ARCHITECTURAL REVIEW BOARD MEETING

PROJECT NUMBER: SP2024-038
PROJECT NAME: Site Plan for Mt. Zion Meter Vault
SITE ADDRESS/LOCATIONS: 3275 N JOHN KING BLVD, ROCKWALL, TX 75032

08/23/2024: SP2024-038: Site Plan for a Municipally Controlled Utility Substation
Please address the following comments (M= Mandatory Comments; I = Informational Comments)

PROJECT NUMBER: SP2024-039
PROJECT NAME: Site Plan for Peachtree Meadows Amenity Center
SITE ADDRESS/LOCATIONS: 1400 CHASTAIN ST, ROCKWALL, TX 75032

1 SITE PLAN - PHOTOMETRICS
SCALE: 1" = 20'-0"

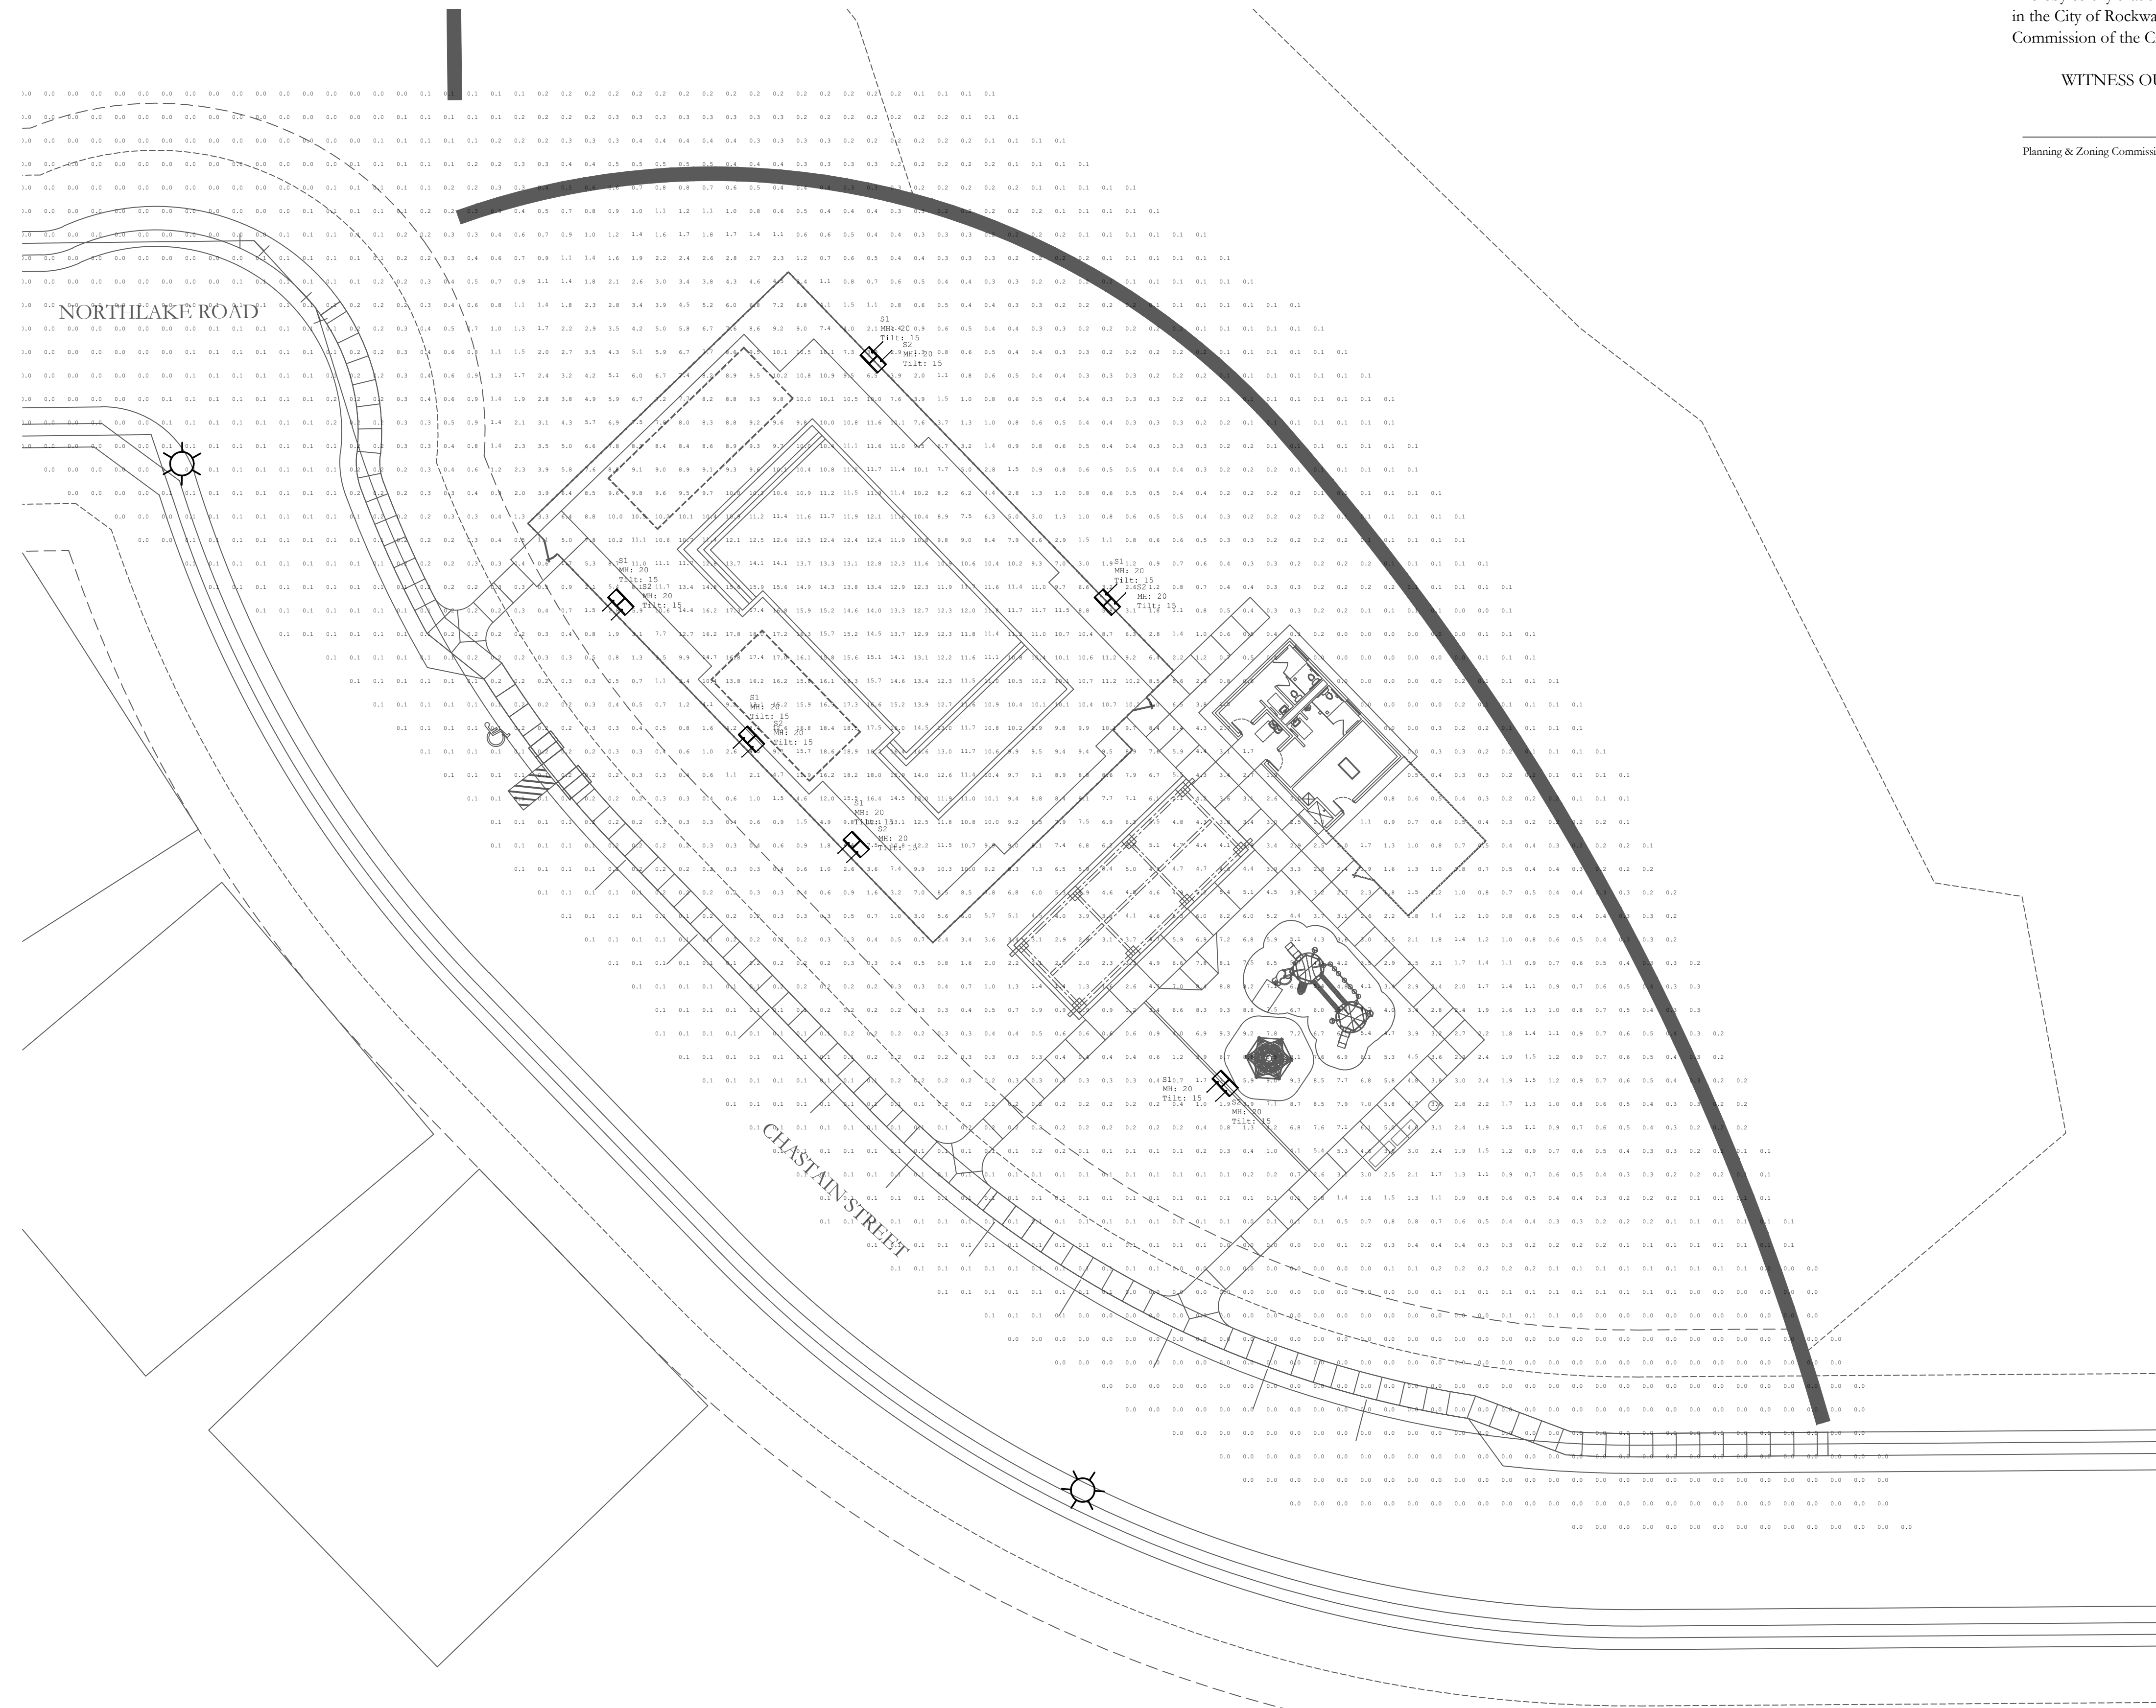
M.5 Photometric Plan:
